**Warrnambool Asphalt Batch Plant  
Fulton Hogan**

**Response to Council RFI**

Planning Permit Application # PP2022-0016

Figure 8: Predicted Incremental Annual Average SO<sub>2</sub> Concentration (ug/m<sup>3</sup>) overlaid on Existing RLZ and Potential GRZ Land-Use Zones

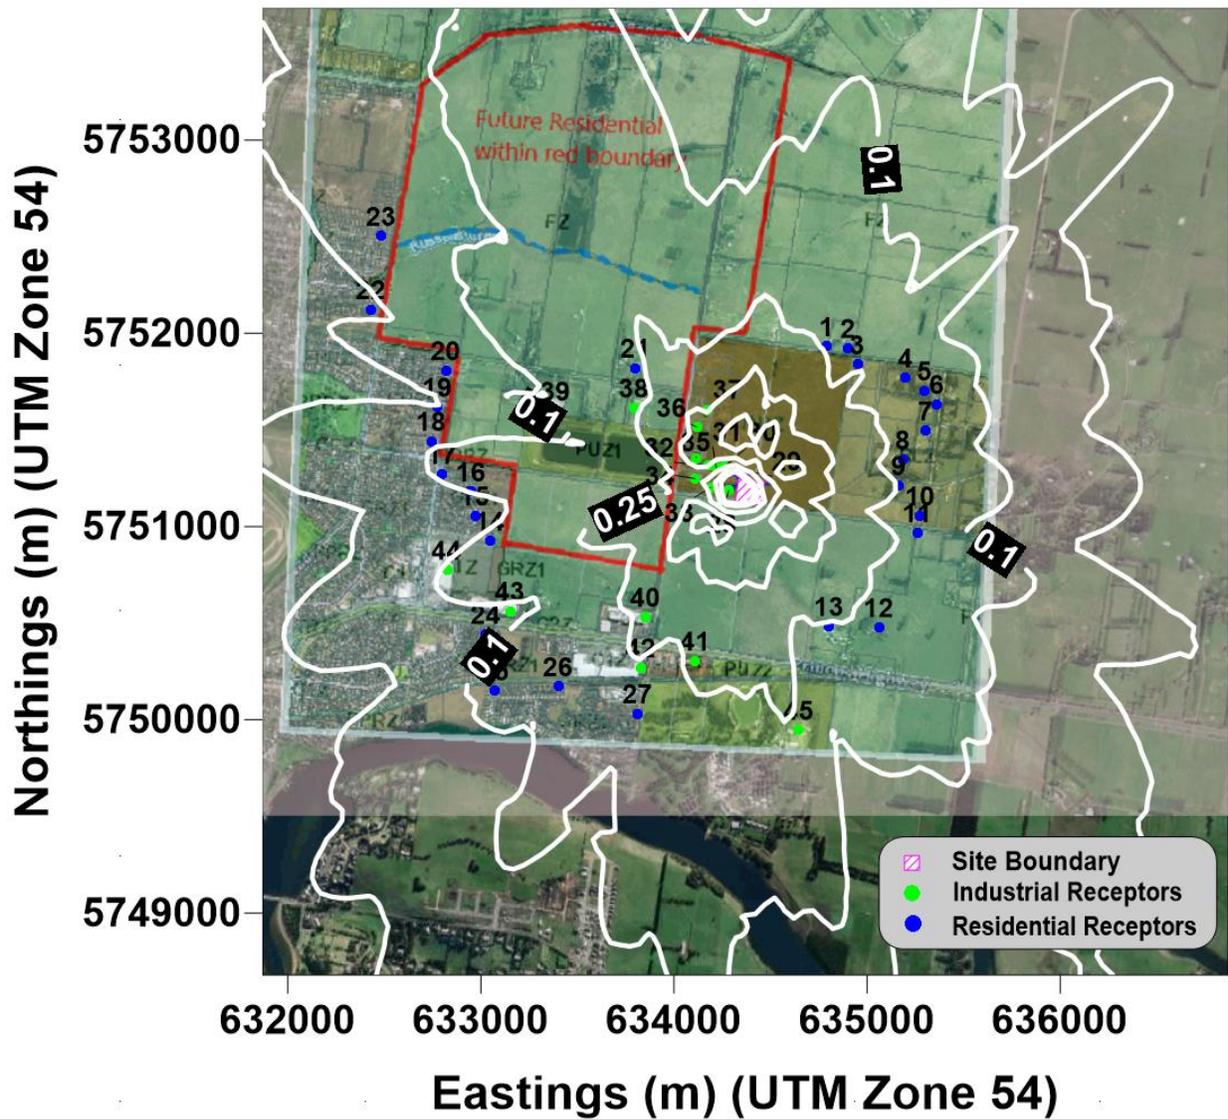
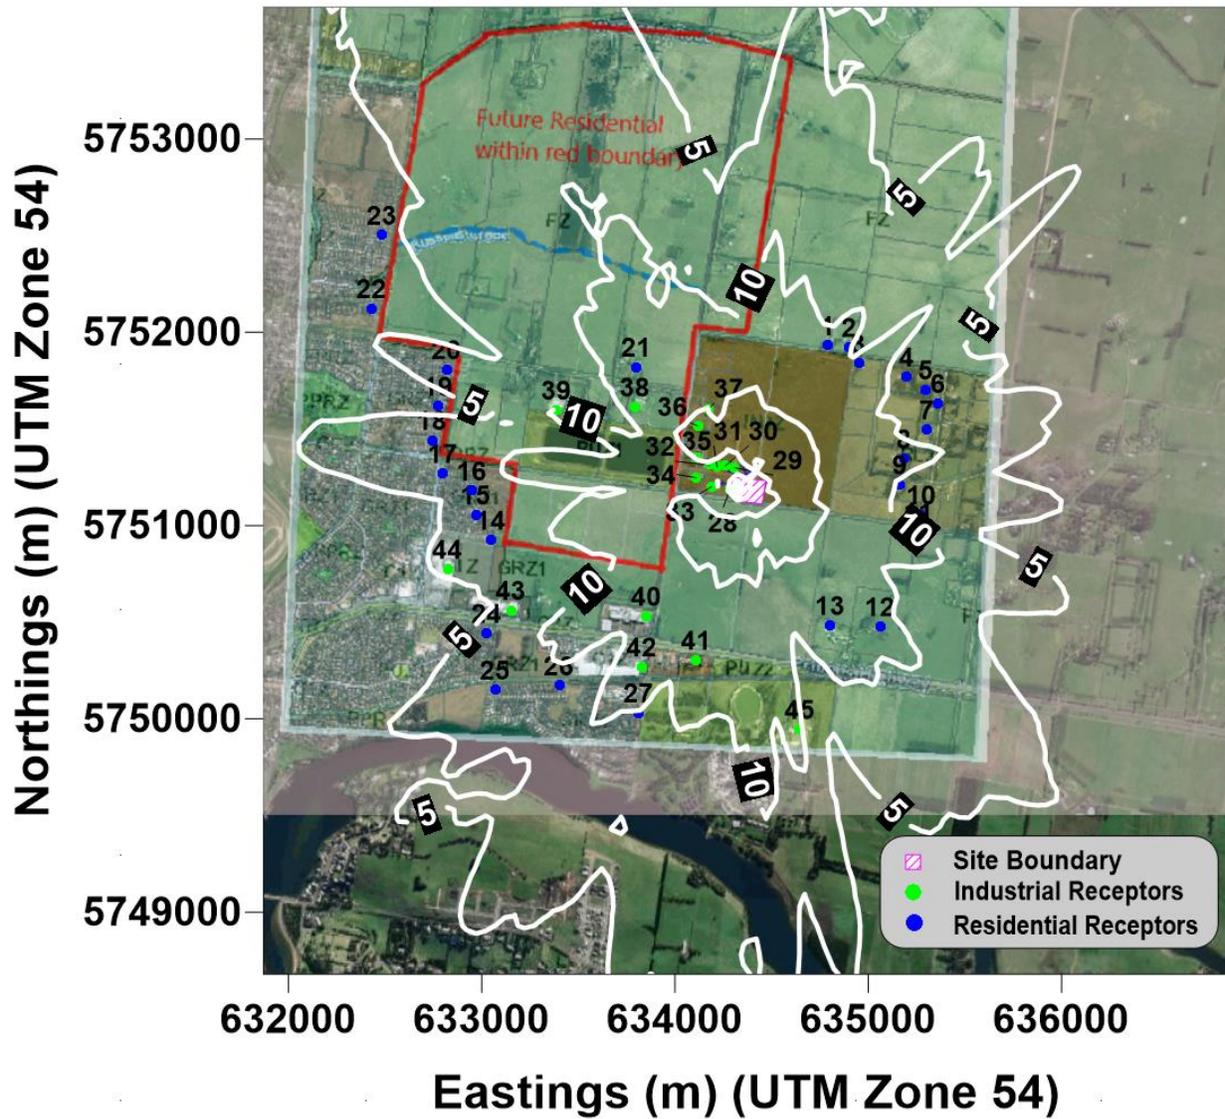
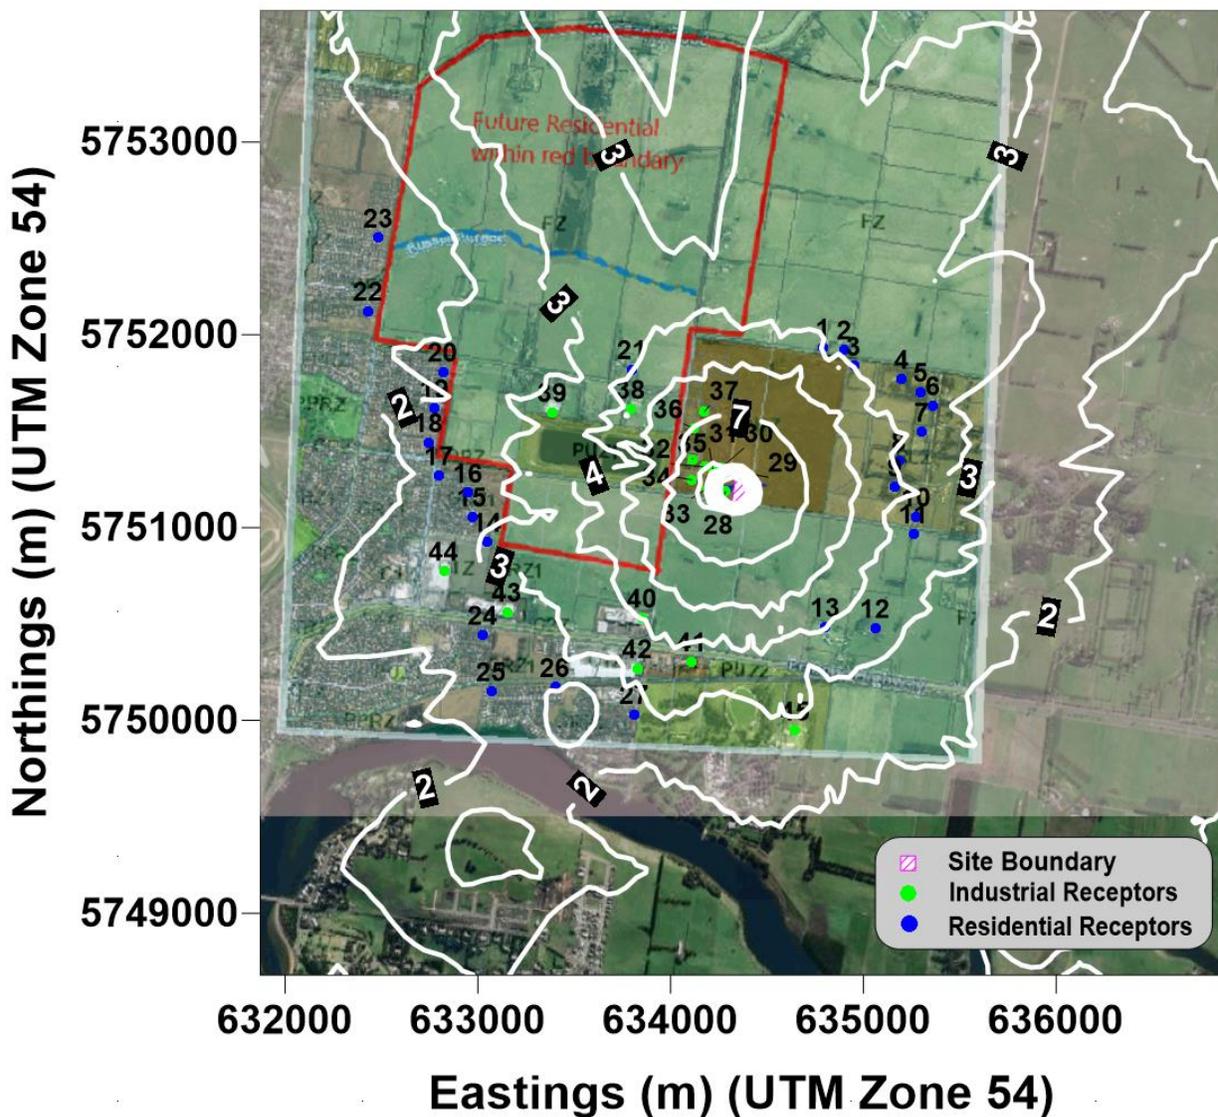
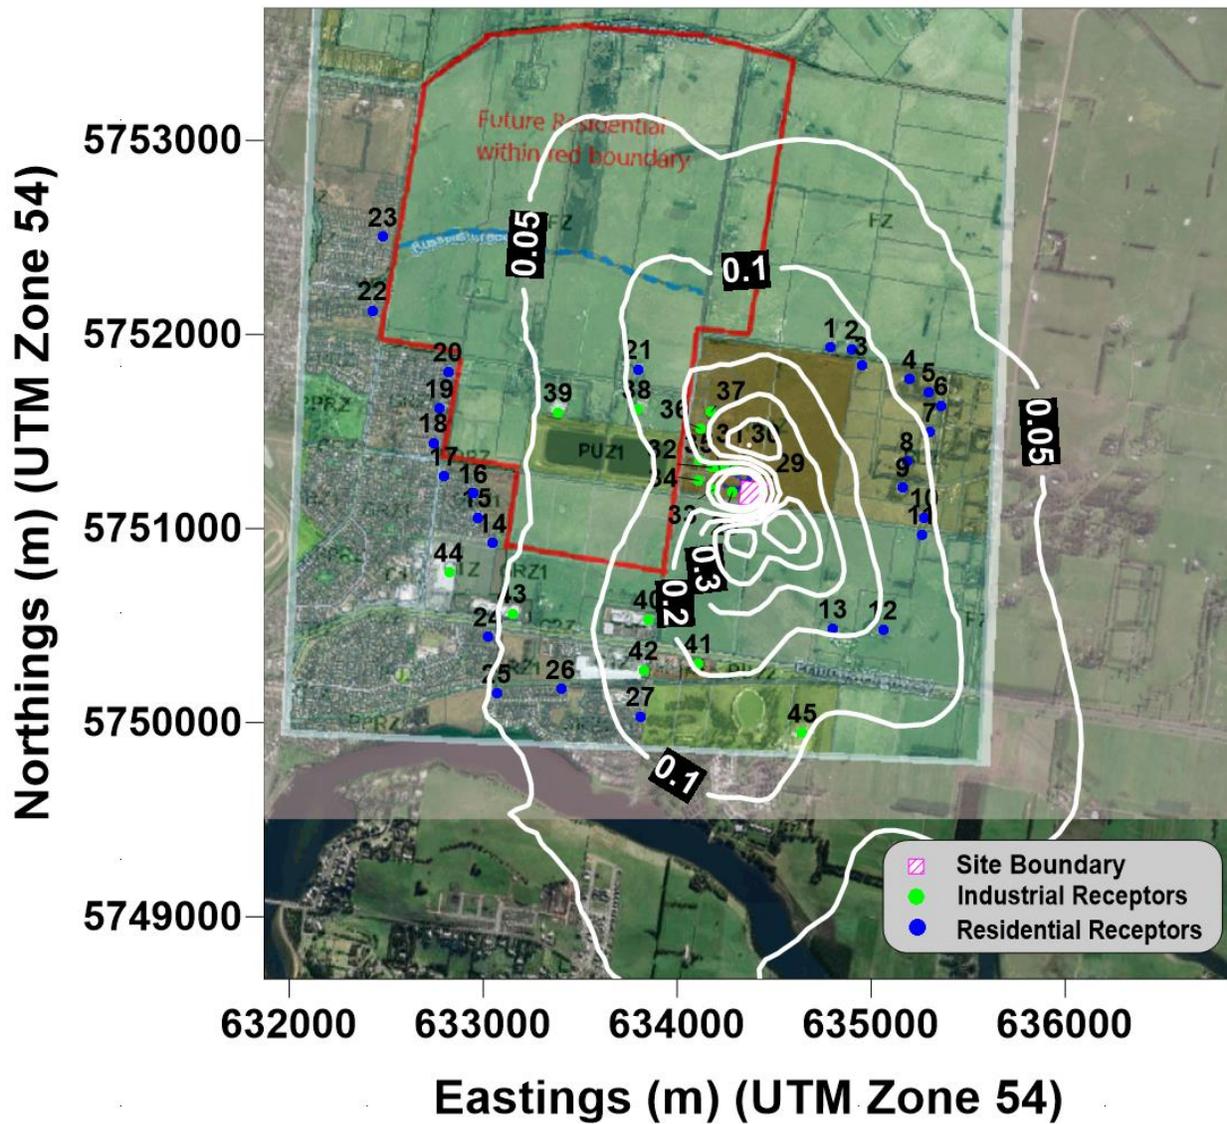
- *Although acknowledged that you can't provide for all future eventualities, all reports fail to consider land identified for future residential as per the structure plan,*
- *The air quality report fails to acknowledge the possible GRZ, and*
- *Both the air quality and acoustic reports fail to use specific sensitive receivers which would be essential in understanding how this particular context will meet the various requirements under the planning scheme. In order to prove that the proposal can meet the objectives in its specific context, it needs justification from all three reports using the sensitive receivers that exist in context and analysed with the localised conditions that will influence the outcome.*

Concentration isopleths for a selection of the modelled pollutants overlaid on the existing RLZ and potential GRZ have been presented in **Figure 2** through to **Figure 11**. It is to be noted that concentration isopleths have been presented as incremental impacts (i.e. impacts from the proposed development only).

Upon examining the concentration isopleths presented in **Figure 2** through to **Figure 11**, it is observed that the isopleths show relatively consistent reduction in pollutant concentrations with distance from site implying that receptors further from the site will experience lower concentrations than those closer to the site. Now as per the Airlabs report, all sensitive receptors many of which were much closer to the site than the existing RLZ and potential GRZ were compliant with the criteria and therefore the implication is that the existing RLZ and potential GRZ land parcel too are compliant. It is acknowledged that the concentration isopleths overlaid on the existing RLZ and potential GRZ land parcels are incremental impacts (i.e. contribution from the proposed development only) and not the cumulative impacts (incremental + background). However, examination of the modelling results presented in the Airlabs Report clearly shows that cumulative ground level concentrations for all the modelled pollutants comply with the relevant assessment criteria across all of the 45 sensitive receptors and also that the background concentrations are the main contributor for the cumulative concentrations, which indicate the limited contribution expected from the proposed development. Therefore, isopleths have been presented only for the incremental impacts to understand the proposed development's expected impacts on the existing RLZ and potential GRZ land parcels.

Therefore, based on the above discussions and the concentration isopleths presented in **Figure 2** through to **Figure 11**, it is clearly evident that the proposed development activities would be compliant with the air quality criteria at the existing RLZ and potential GRZ land parcels.

Figure 5: At 325 m

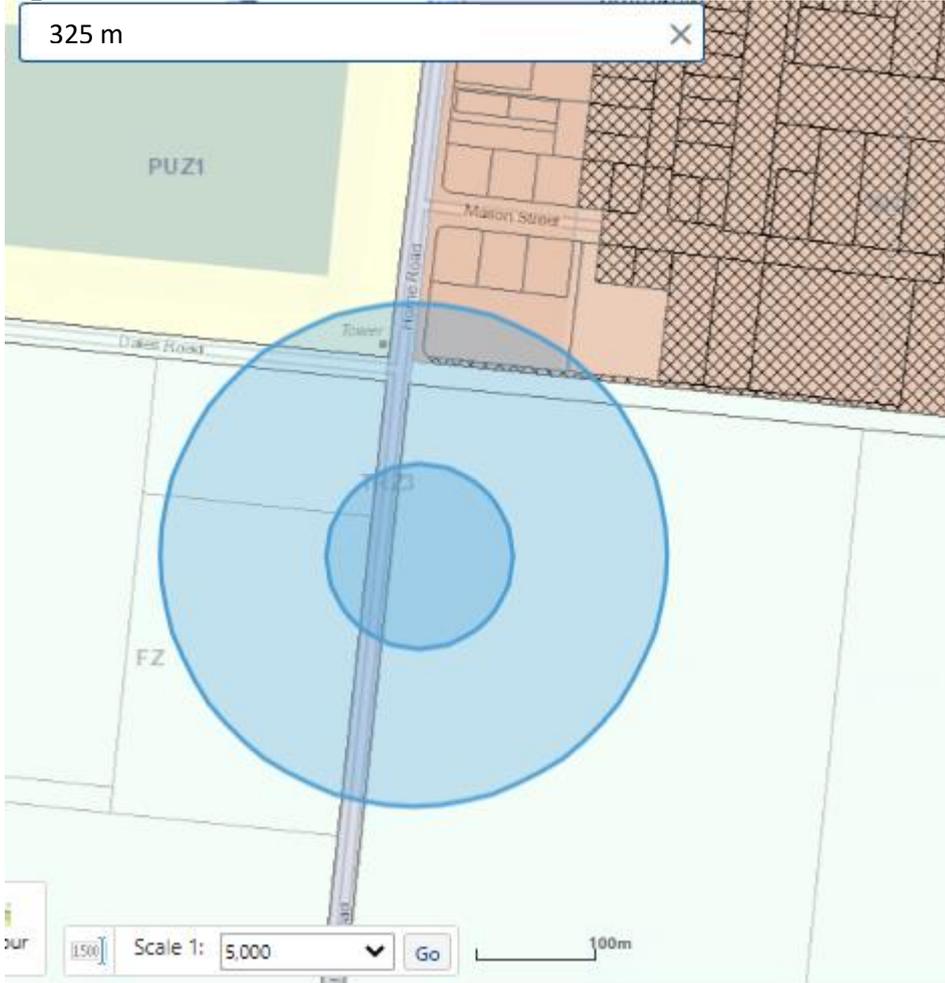
- *The acoustic report analyses areas further out (140 Boiling Down, 21 Veal at 600-700m), but fails to make mention of the existing RLZ at 400m, or the potential GRZ at 325m.*

Using the same methodology, we have determined noise limits for the distances at 325 m and 400 m off the proposed asphalt plant.

Based on the calculations and field measurements we conclude that the proposed asphalt plant at 58-58A Dales Road, Warrnambool will comply with the Protocol's noise limits at the nearest noise sensitive receivers including distances at 325 m, the nearest point of the proposed General Residential Zone and at 400 m , the nearest point of the existing Rural Living Zone .

Figure 1 Wind Roses – BoM station Warrnambool Airport NDB (No 090186)

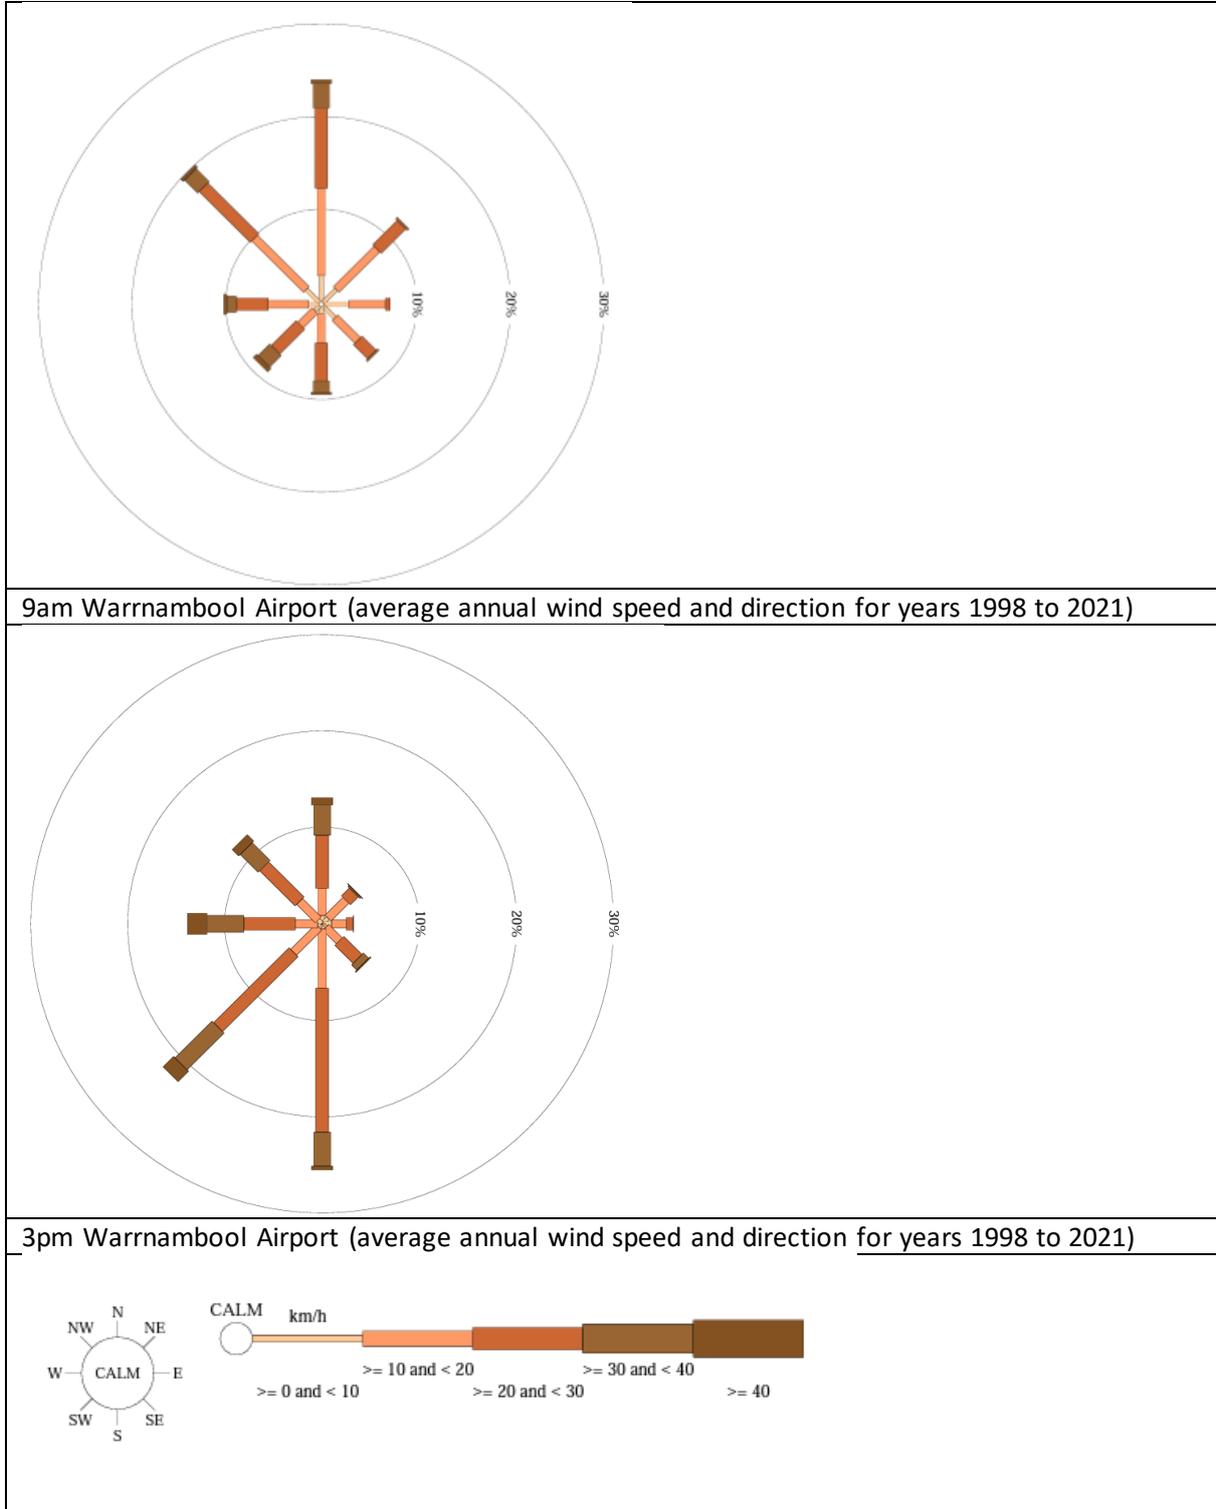
- *The odour report makes reference to another plant in Dandenong and therefore doesn't address specific local meteorological conditions. This would be essential in providing assurance that the use is appropriate at this particular site. Local prevailing wind patterns and the specific orientation of the site itself need to be understood.*
- *Although acknowledged that you can't provide for all future eventualities, all reports fail to consider land identified for future residential as per the structure plan.*
- *In order to prove that the proposal can meet the objectives in its specific context, it needs justification from all three reports using the sensitive receivers that exist in context and analysed with the localized conditions that will influence the outcome.*

With regard to Council's comment, '*Although acknowledged that you can't provide for all future eventualities, all reports fail to consider land identified for future residential as per the structure plan*'. While it is considered inappropriate to assess odour impacts at a receiver that does not exist, for the purposes of supporting our response (at Section 2.4.3) to Council's comment, the following initial assessment of prevailing wind conditions is provided:

- Wind roses (from Warrnambool Airport for the period 1998 to 2021) sourced from Bureau of Meteorology, presented at Figure 1 below, indicate easterly winds occur at a very low frequency.
- Prevailing winds tend to be north / north-west at 9am (offshore morning winds) versus south / southwest winds at 3pm (afternoon onshore winds)
- Winds from due east (that would direct odour from the site toward the potential GRZ to the west) occur approximately 8% of the time at 9am and 3% of the time at 3pm.
